Work Order ID 92701

Item Name: Crosstube Aft

DART SERVICE INSTRUCTION

DRAWING NO. D212-664-241	TITLE CROSSTUBE ASSY (205/212 HI AFT)	REV. D	DART AEROSPACE LTD ENGINEERING ORDER		D.E.O. NO. D212-664-241-D-1	SHEET NO. SHEET 1 OF 2	SCALE NTS
DRAWN	CHECKED	MFG. APPR.	APPROVED	DE APPR.			
DATE 11.04.07	DATE 11.04.11	DATE 11.04.12	DATE 11/04/12	DATE 11.04.12

FIGURE 1: SUPPORT INSTALLATION

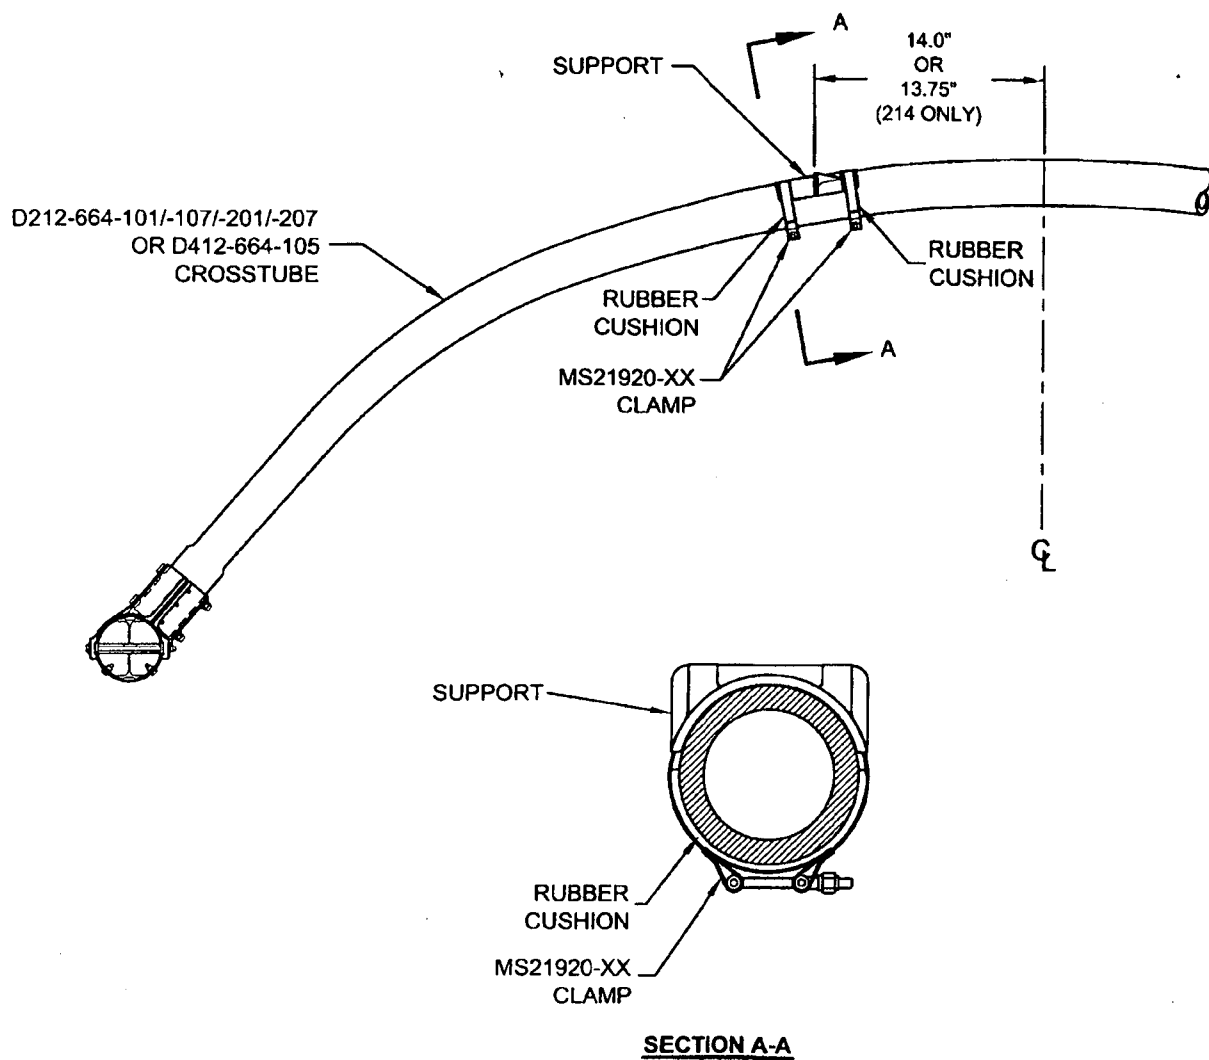
The supports on the following crosstubes are now installed using Proseal instead of Magnobond:

D212-664-101/-101B @ CHG 005
D412-664-105 @ CHG 002
D212-664-107/-107B @ CHG 002

D212-664-201/-201B @ CHG 005
D212-664-207/-207B @ CHG 002

For the crosstubes listed above, section 32.4 of ICA-D212-664 is amended as follows. Use Figure 1 of this service instruction and Figures 32-2 to 32-9 of ICA-D212-664 for further reference. For crosstubes of an earlier change number, it is recommended that if the supports are removed, the supports should be reinstalled using the procedure listed below.

- 32.4.1 Locate the area on the crosstube for installation of support (see Figure 1 of this service instruction). For D212-664-101/-107/-201/-207 and D412-664-105 crosstubes, the outward face of the support tabs should be 14.0" (355mm) from the crosstube center for 204/205/210/412/UH-1 aircraft. For installation on 214B/B-1 aircraft, the outward face of the support tabs should be 13.75" (349mm). Ensure paint finish of crosstube is intact; touch up as required per Chapter 5 (5.3.9) of ICA-D212-664.

- 32.4.2 If present, remove any paint/primer on bottom of supports. Abrade mating surfaces of support and crosstube with 400-grit sandpaper. Saturate a clean cloth with MEK or 4105S Wash'n'Wipe Degreaser or equivalent and wipe until there is no residue.

- 32.4.3 Ensure a layer of 3M Scotch-Weld 2216 B/A Epoxy Adhesive is on the bottom of the support. If required, either apply or touch-up support to have a 0.03" to 0.05" thick layer of adhesive over the entire mating surface. Allow supports to cure for 24 hours.

- 32.4.4 Abrade mating surfaces of support (after cure) and crosstube with 180-grit sandpaper. Saturate a clean cloth with MEK or 4105S Wash'n'Wipe Degreaser or equivalent and wipe until there is no residue.

- 32.4.5 Apply a 0.04" to 0.07" thick layer of Proseal 890 Class B or AMS-S-8802 Class B sealant underneath applicable support and install support as shown in Figure 1 of this service instruction.

- 32.4.6 Install the clamps opposite to crosstube support as shown in section A-A of Figure 1. Install rubber cushions underneath each clamp around the bottom circumference of the crosstube up to the crosstube centerline. Torque clamps 80-100 in-lb (9.0-11.3 Nm). It is acceptable to use smaller or larger sized MS21920-XX clamps than those listed in ICA-D212-664, ensure that after torquing the clamps per this instruction, the nuts are in safety but not bottomed out

- 32.4.7 Prior to installing crosstube on aircraft, allow supports to cure for 72 hours and recheck torque on clamps.

DART AEROSPACE LTD		Work Order:	92701
Description: Crosstube High Aft (205/212)		Part Number:	D212-664-201
Inspection Dwg: D212-664-241 Rev: D		Page 1 of 1

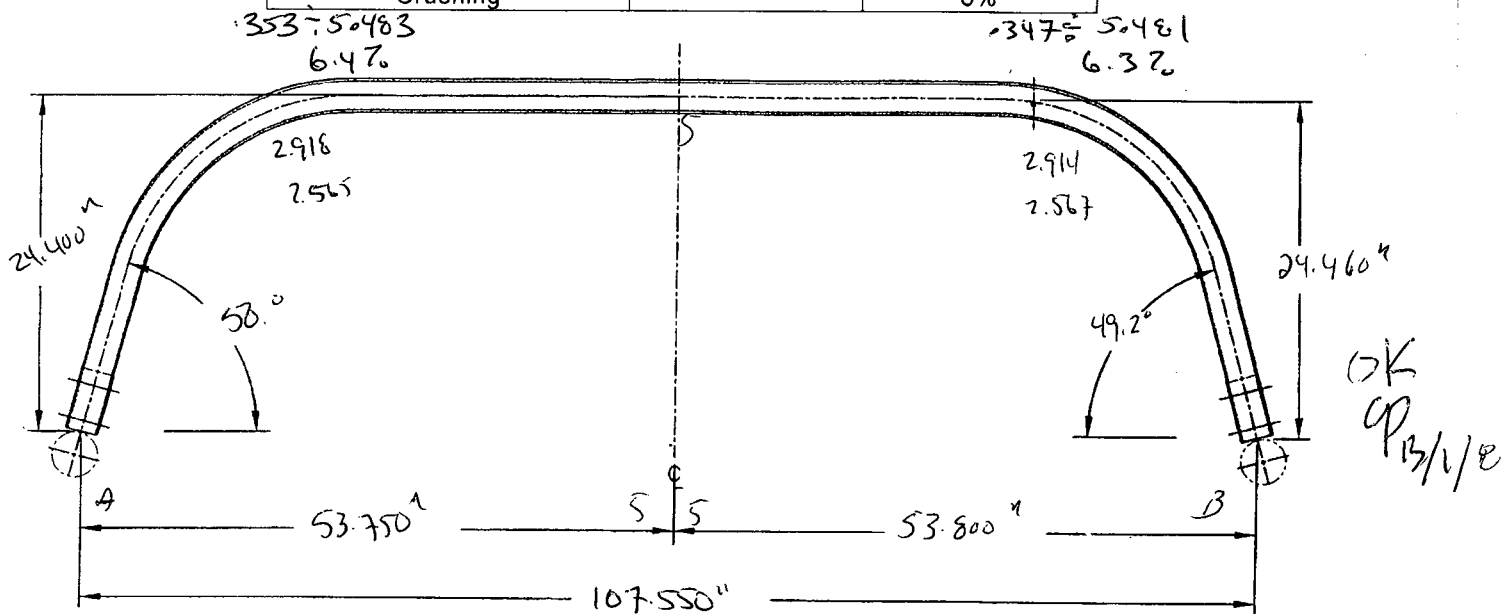
Side A	middle	Side B
Bending Passes	5	5	5
Crushing	6.47%		6.37%
Comments			
Side A = 6.47% crushing @ 5 Passes			
middle = 5 Passes			
Side B = 6.37% crushing @ 5 Passes

Acceptability of 8% CRUSHING

Point A: $OD = 2.548$ in $OD = 2.492$ in
 CRUSHING $(2.992 - 2.548) / (2.992 + 2.548) = 8\%$
 $I = 1.476$ in⁴

The will fail at support before area of 8% CRUSHING, 8% CRUSHING AT END AT BEND IS ACCEPTABLE

D212-664-241/-241B
ASSEMBLY DETAIL

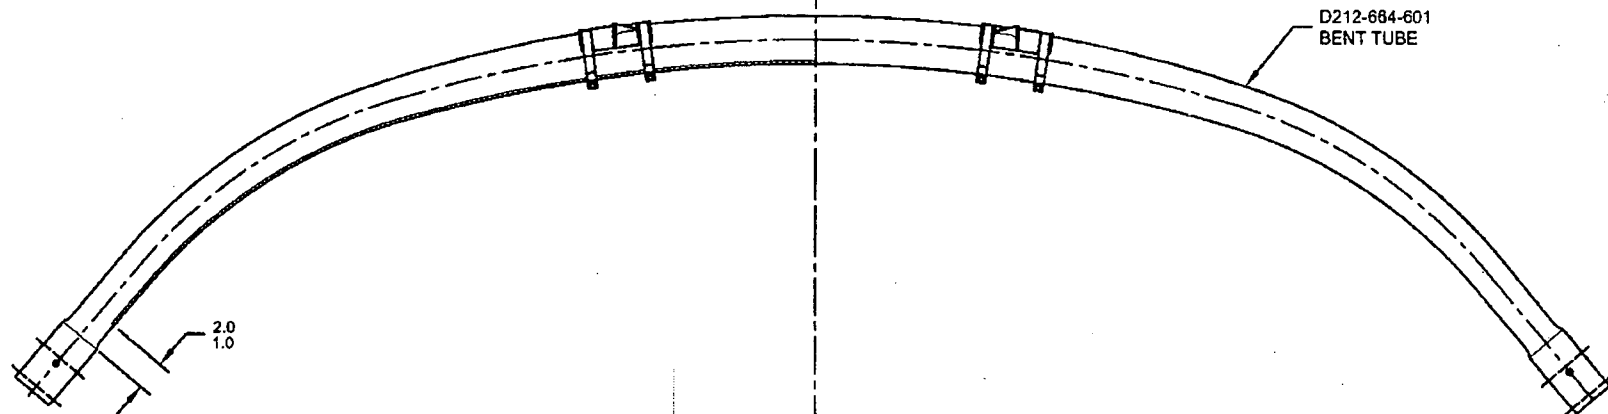
ADD AN INSPECTION WINDOW TO UNDERSIDE OF CROSSTUBE.

NOTES 2 OF SHEET 1 IS AMENDED AS FOLLOWS:

- 2) FINISH: CHEMICAL CONVERSION COAT PER DART QSI 005 4.1
PRIME INSIDE AND OUTSIDE PER DART QSI 005 4.2
MASK UNDERSIDE OF CROSSTUBE AS SHOWN (HATCHED AREA) AND
PAINT OUTSIDE PER DART QSI 005 4.2
REMOVE MASKING AND APPLY CLEAR COAT

MASK AREA PRIOR TO PAINTING,
REMOVE MASKING AFTER PAINT
AND APPLY CLEAR COAT

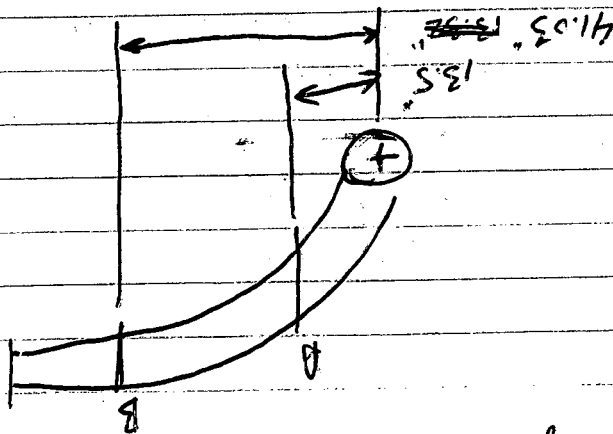
REPLACE MAGNOBOND WITH PROSEAL.

NOTE 12 & 15, SHEET 1 IS AMENDED AS FOLLOWS:

- 12) TO INSTALL D2940-1 SUPPORT: ABRASE MATING SURFACE OF SUPPORT AND CROSSTUBE WITH 180-GRIT SANDPAPER AND REMOVE RESIDUE WITH MEK (OR EQUIVALENT). APPLY A 0.04" TO 0.07" THICK LAYER OF PROSEAL 890 CLASS B-2 (OR AMS-S-8802 CLASS B-2) SEALANT TO MATING SURFACE OF SUPPORT.
- 15) TORQUE CLAMPS 80 TO 100 IN-LB. ENSURE AT LEAST 1.5 THREADS SHOWING IN SAFETY AND THAT NUT HAS NOT BOTTOMED-OUT AFTER TORQUING. **PRIOR TO PACKAGING, RE-CHECK TORQUE ON CLAMPS AFTER PROSEAL 890 SEALANT HAS CURED FOR 72 HOURS.**
